FINAL DRAFT MINUTES

July 20, 2023 Standards Committee Meeting

RE: Minutes from the July 20, 2023 Standards Committee Meeting

E 801-TCCB-01 TEMPORARY CONCRETE BARRIER INDEX SHEET (WITH MARKUPS)

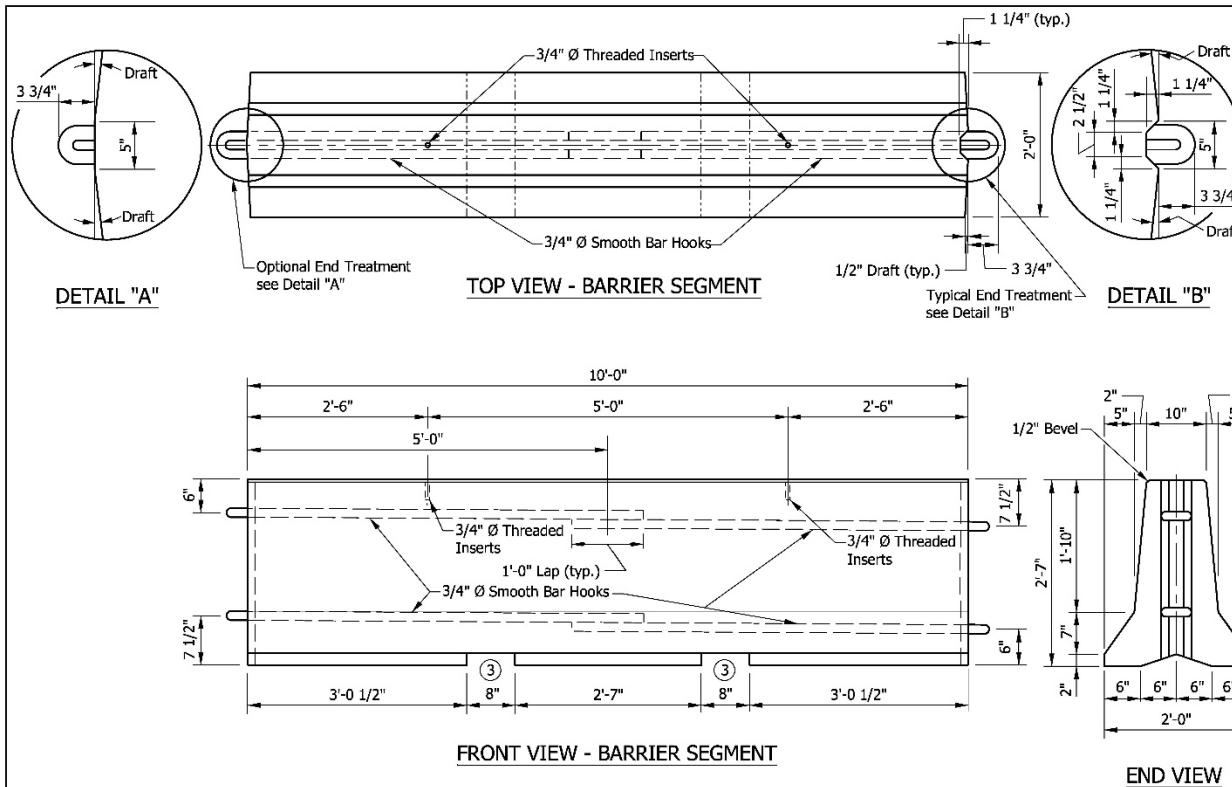
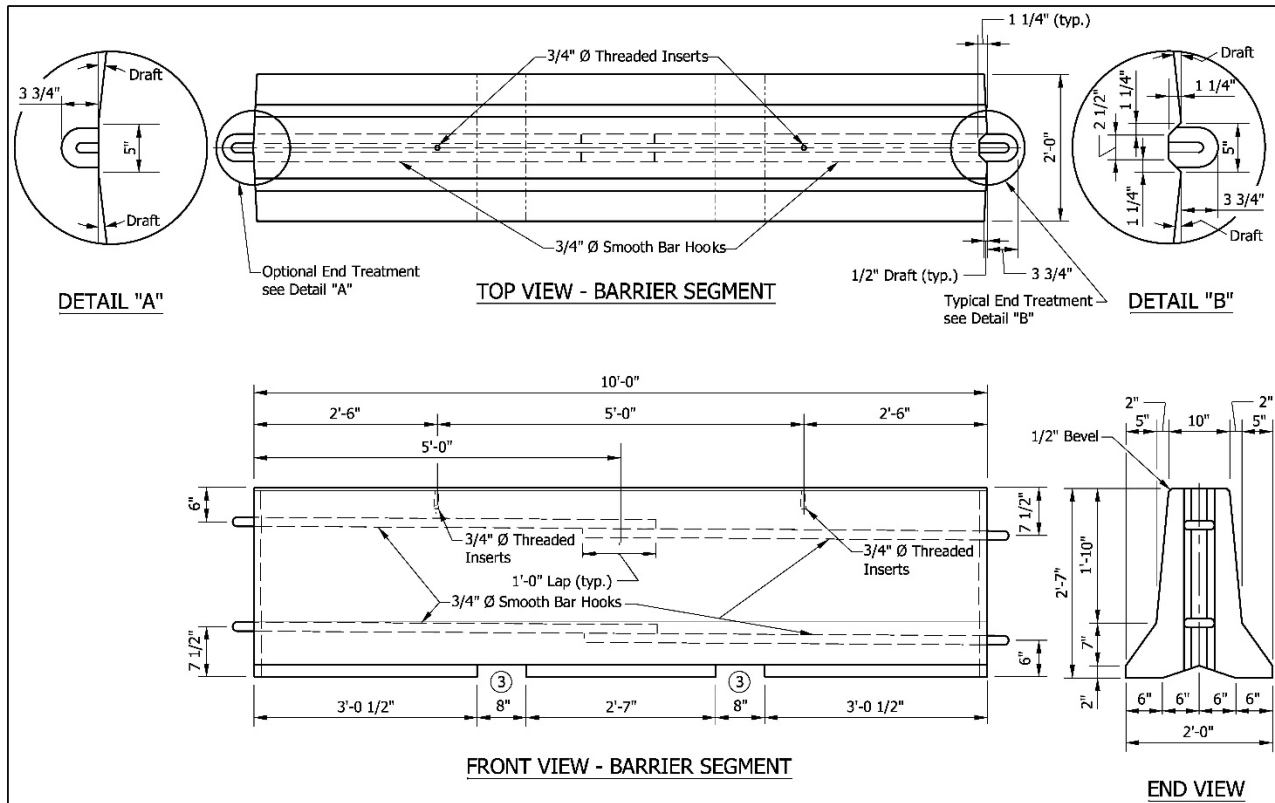
MARK-UP Editorial change to index this sheet

INDEX	
SHEET NO.	SUBJECT
1	Temporary Concrete Barrier Index Sheet
2	Temporary Concrete Barrier Dimensions <i>and Flare Rates</i>
3	Temporary Concrete Barrier Details
4	Temporary Concrete Barrier Double Taper End Section
5	Anchored Temporary Concrete Barrier, Drop-In Anchor
6	Anchored Temporary Concrete Barrier, Ferrule Loop Insert

INDEX	
SHEET NO.	SUBJECT
1	Temporary Concrete Barrier Index Sheet
2	Temporary Concrete Barrier Dimensions and Flare Rates
3	Temporary Concrete Barrier Details
4	Temporary Concrete Barrier Double Taper End Section
5	Anchored Temporary Concrete Barrier, Drop-In Anchor
6	Anchored Temporary Concrete Barrier, Ferrule Loop Insert

E 801-TCCB-02 TEMPORARY CONCRETE BARRIER DIMENSIONS (WITH REVISED MARKUPS)

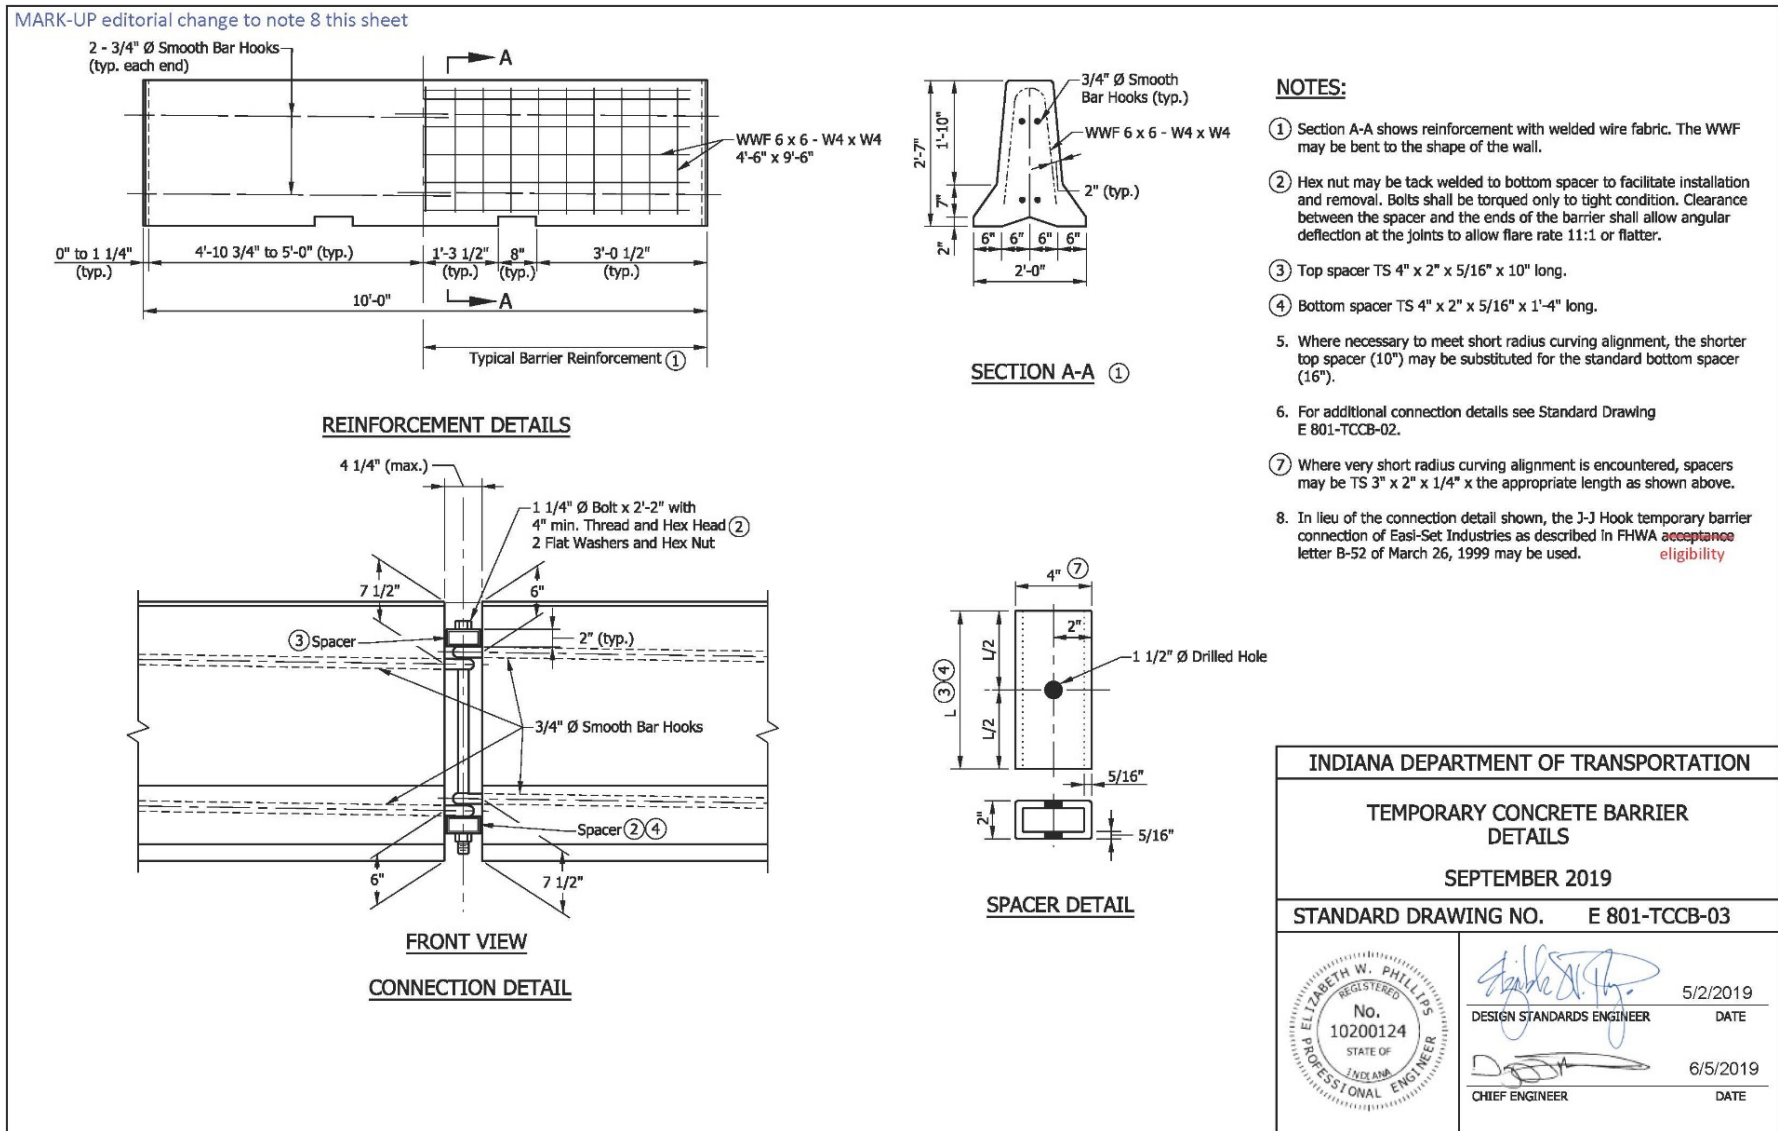
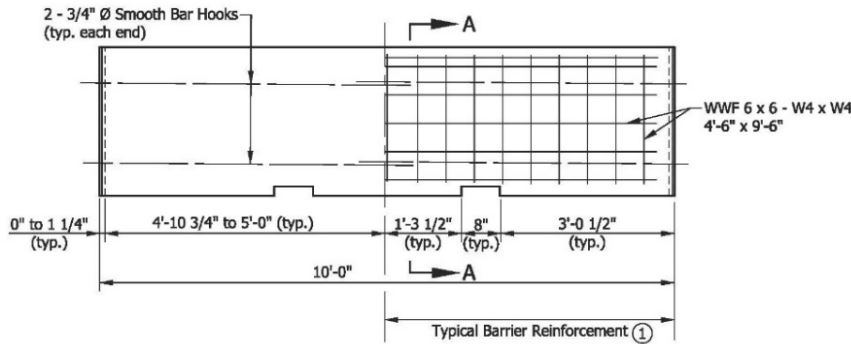
PROPOSED SOLUTION: Within 801.10, delete the existing language that allows extreme modification of the flare rate and offset of the termination point of temporary traffic barrier and add in more descriptive termination allowances.

In addition, clarify how type 1, type 2, type 3, and type 4 temporary traffic barrier and CZ units can be applied and criteria the devices should meet. Within 801.03, propose to require the CWTS to be responsible for the condition of the temporary traffic barrier by deleting the exception of the temporary traffic barrier and require the CWTS to provide a copy of the ATSSA Quality Standards for Temporary Traffic Control Devices booklet when requested by the Engineer.

- For freeways and interstates, the maximum barrier flare rate and construction clear zone distance shall be based on 70 mph for the first run of barrier within the construction zone. For subsequent barrier placement, the barrier flare rates and construction clear zone distance shall be based on 70 mph unless otherwise shown on the plans. **The barrier taper flare rate**
- Maximum barrier taper rate flare** and construction clear zone distance ~~for construction zone speed~~ are shown in Table No. 1. Construction clear zone distance is measured from the through travel lane. **The barrier taper flare rate shall be as shown or flatter.**
- The dimensions of the lifting slots are subject to adjustment as necessary to accommodate handling equipment.
- For additional connection details see Standard Drawing E 801-TCCB-03.

- 1 For freeways and interstates, the maximum barrier flare rate and construction clear zone distance shall be based on 70 mph for the first run of barrier within the construction zone. For subsequent barrier placement, the barrier flare rates and construction clear zone distance shall be based on 70 mph unless otherwise shown on the plans.
- 2 The barrier taper flare rate and construction clear zone distance are shown in Table No. 1. Construction clear zone distance is measured from the through travel lane. The barrier taper flare rate shall be as shown or flatter
- 3 The dimensions of the lifting slots are subject to adjustment as necessary to accommodate handling equipment.
- 4 For additional connection details see Standard Drawing E 801-TCCB-03.

E 801-TCCB-03 TEMPORARY CONCRETE BARRIER DETAILS (EDITORIAL CHANGE)

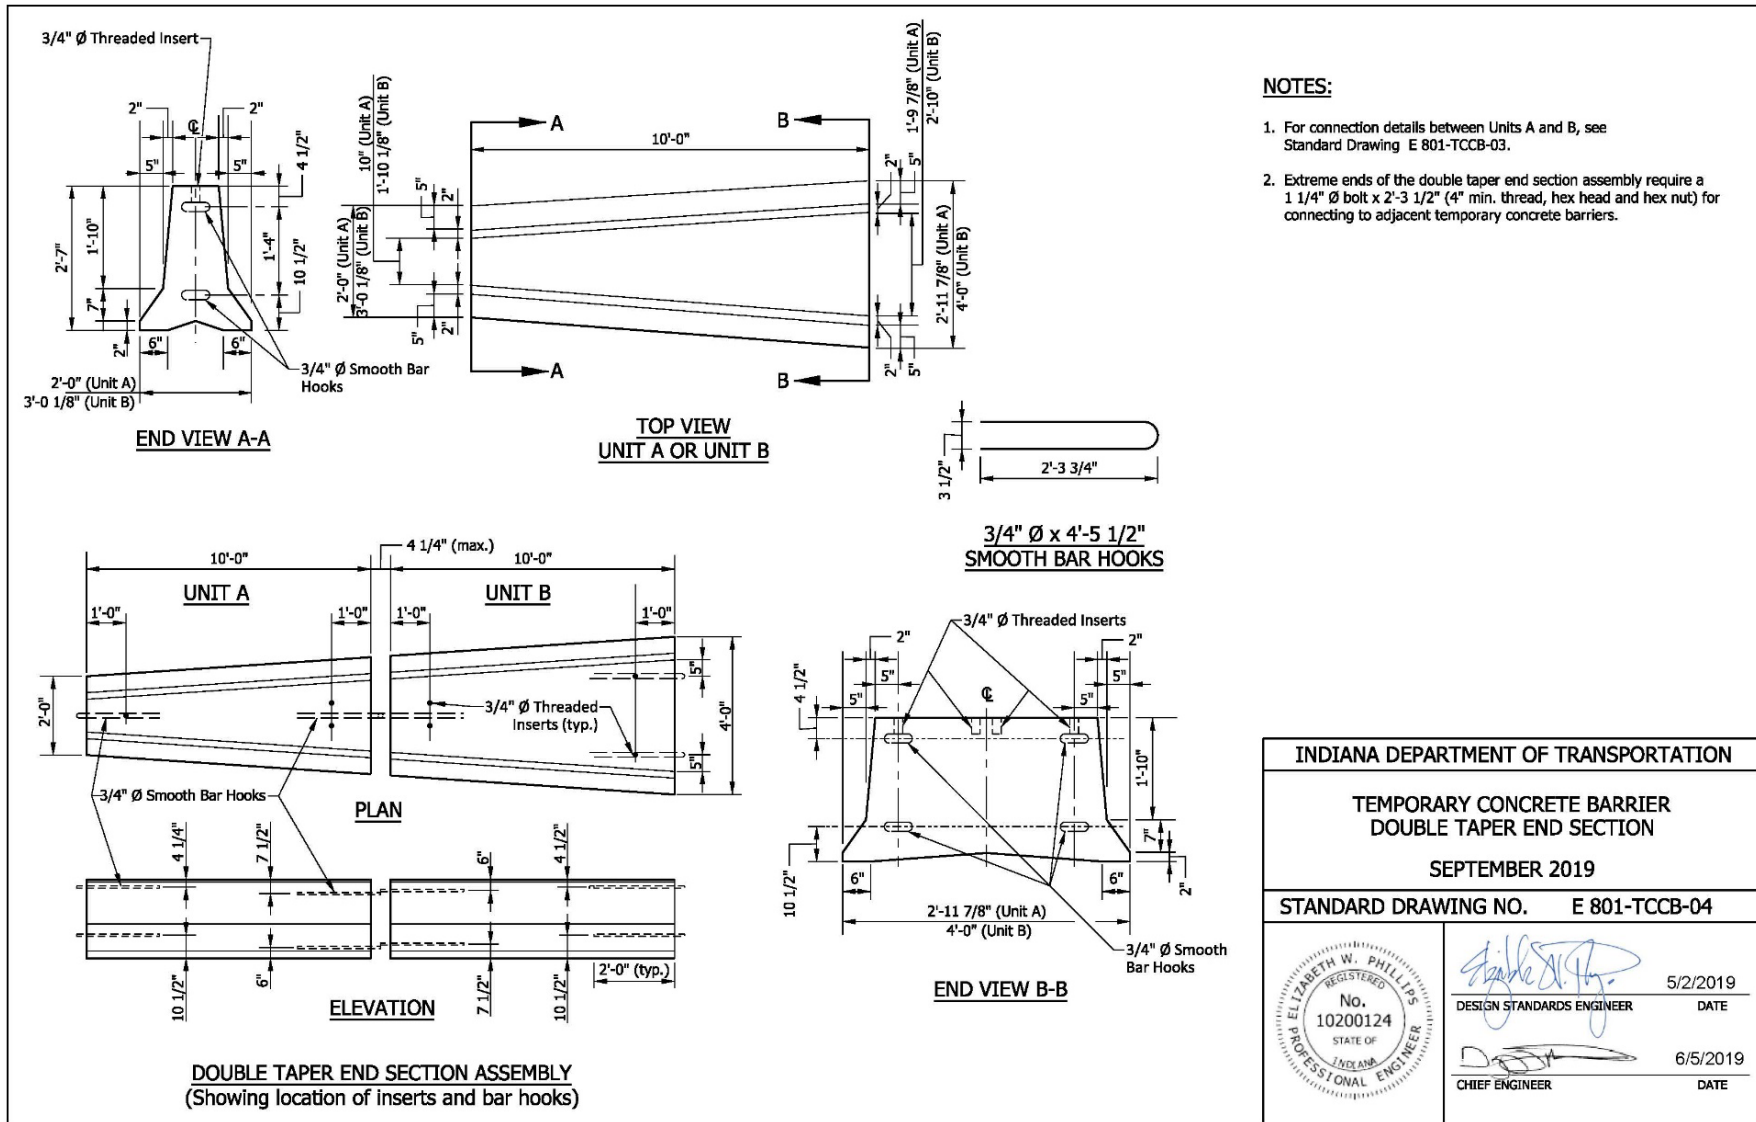
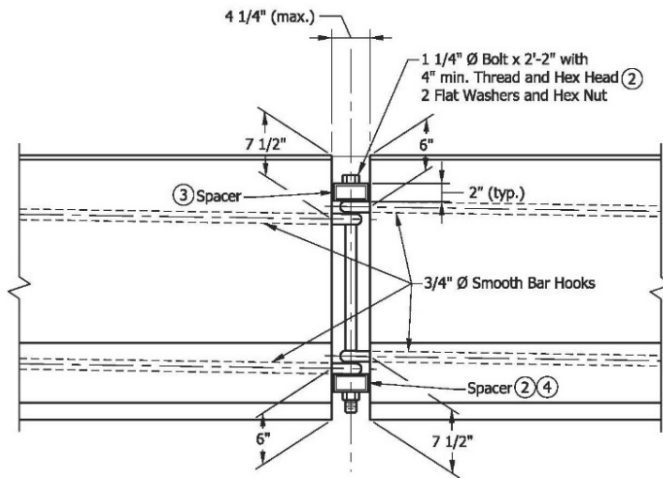
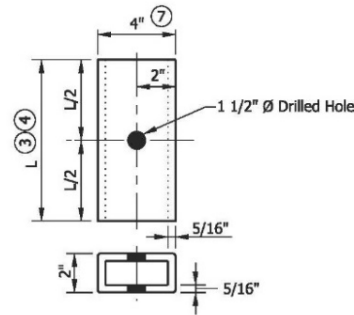
6. For additional connection details see Standard Drawing E 801-TCCB-02.
- ⑦ Where very short radius curving alignment is encountered, spacers may be TS 3" x 2" x 1/4" x the appropriate length as shown above.

8. In lieu of the connection detail shown, the J-J Hook temporary barrier connection of Easi-Set Industries as described in FHWA eligibility letter B-52 of March 26, 1999 may be used.

1. TTB Flared with End Outside Construction Clear Zone

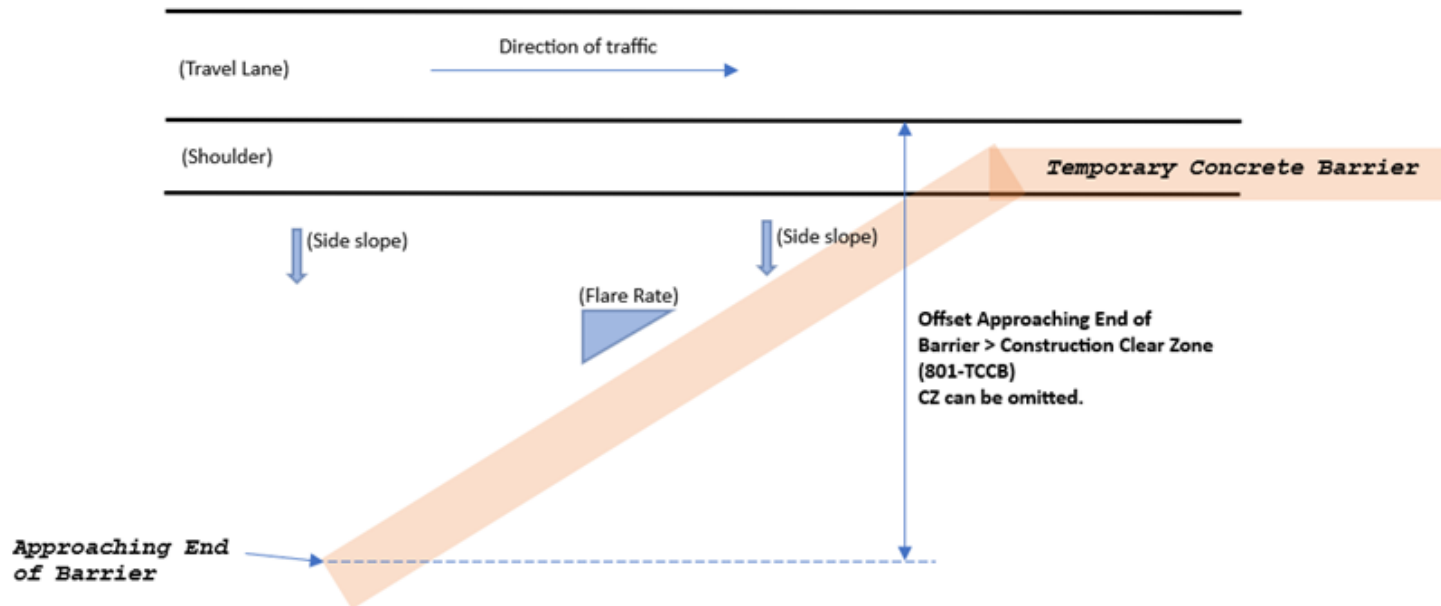
- (Freeway/Interstate) Side slope on approach and under barrier must be 10:1 or flatter. Other roadways 4:1 max**
- Barrier flare rate must be equal to or flatter than required based on Construction Zone Speed**

Proposed revisions for RSP 801-T-207 and Standard Drawing series 801-TCCB are as described in the proposal sheet and shown above. Ms. Mouser shared additional intended revisions to the drawings and GIFE changes.

2. TTB Parallel to Traffic with CZ

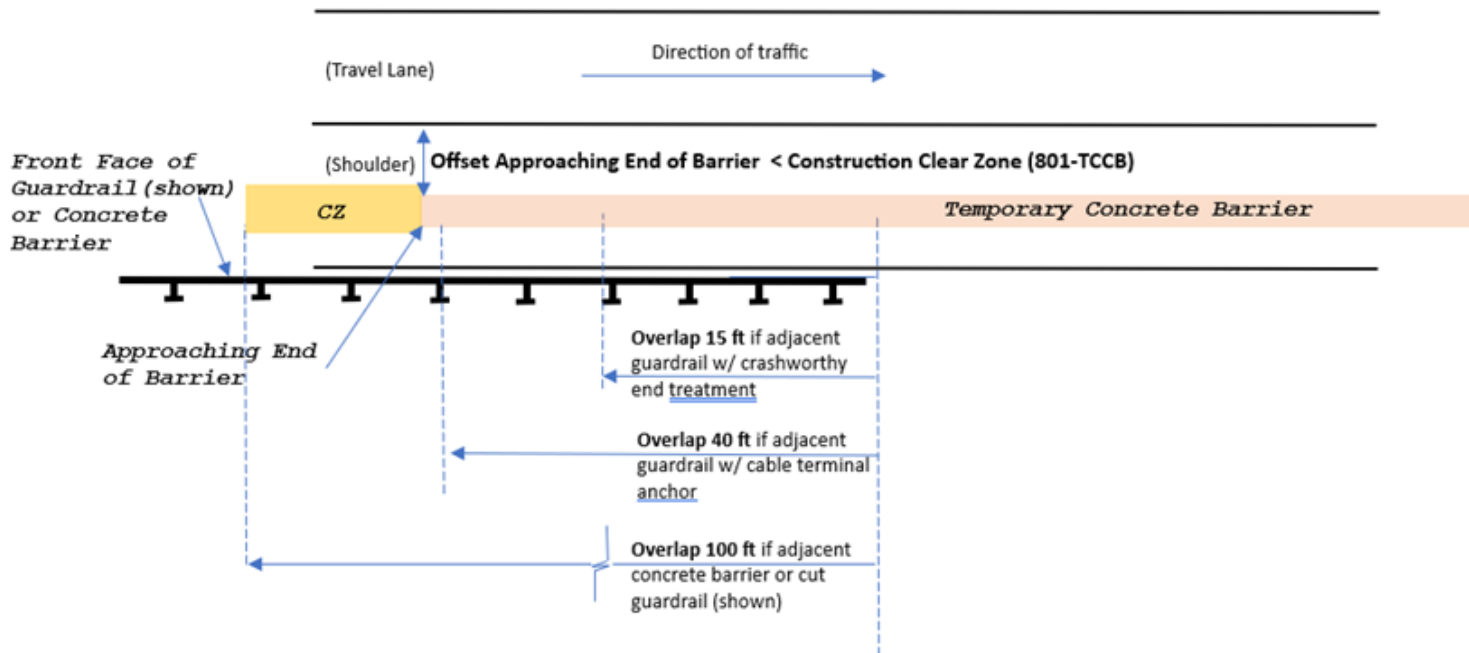
- Approach end of TTB must overlap guardrail or concrete barrier by required distance shown.

E 609-BRJT-01 TYPE I-A JOINT (WITH MARKUPS)

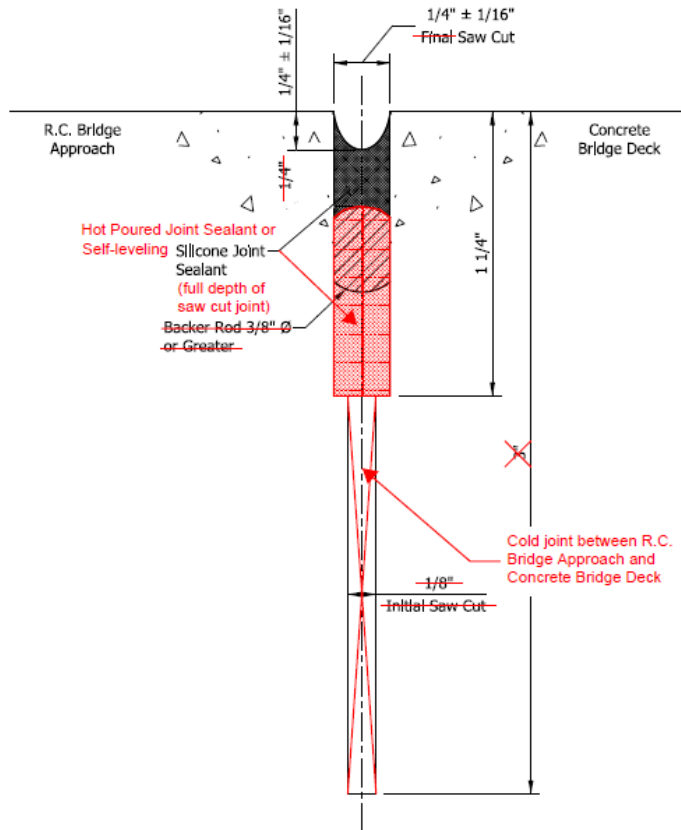
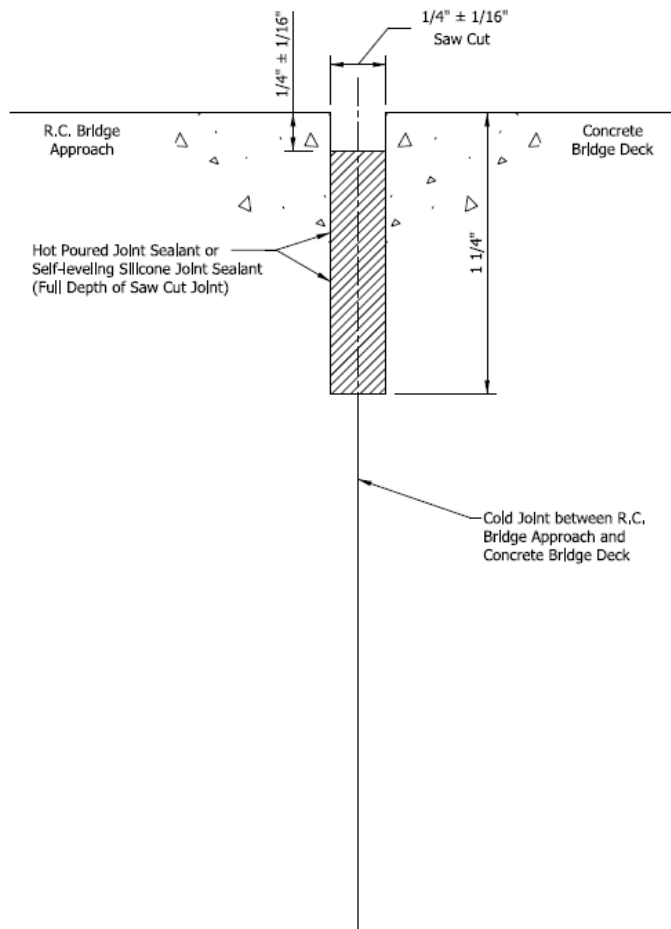
PROBLEM(S) ENCOUNTERED: The current detail for Type I-A joints includes a backer rod to limit the depth of silicone sealant to the upper ½ in. of the joint, leaving the remaining depth open. Research has shown that this creates a space for moisture to enter once the sealant breaks down, causing the space below the sealant to experience more rapid deterioration of the concrete.

This item was introduced and presented by Mr. White who explained that the current detail for Type I-A joints includes a backer rod to limit the depth of silicone sealant to the upper 1/2 in. of the joint, leaving the remaining depth open. Research has shown that this creates a space for moisture to enter once the sealant breaks down, causing the space below the sealant to experience more rapid deterioration of the concrete. Further clarification was provided by Mr. Nelson.

Mr. Koch said that ideally the standard should be updated to show only hot pour as that is the only viable method for new construction but leave silicone available in the material section potentially allowing the material via USP's for specific situations.

PROPOSED SOLUTION: Similar to the current joint details for concrete pavement shown in Standard Drawing series E 503-CCPJ, the backer rod will be eliminated and the saw cut joint will be completely filled with either silicone or hot poured sealant. The Type I-A joint will also be revised to a single saw cut rather than the current two phase cut to facilitate the complete filling of the joint and simplify construction.

Similar to the current joint details for concrete pavement shown in Standard Drawing series E 503-CCPJ, Mr. White proposed that the backer rod will be eliminated and the saw cut joint will be completely filled with either silicone or hot poured sealant. The Type I-A joint will also be revised to a single saw cut rather than the current two phase cut to facilitate the complete filling of the joint and simplify construction.
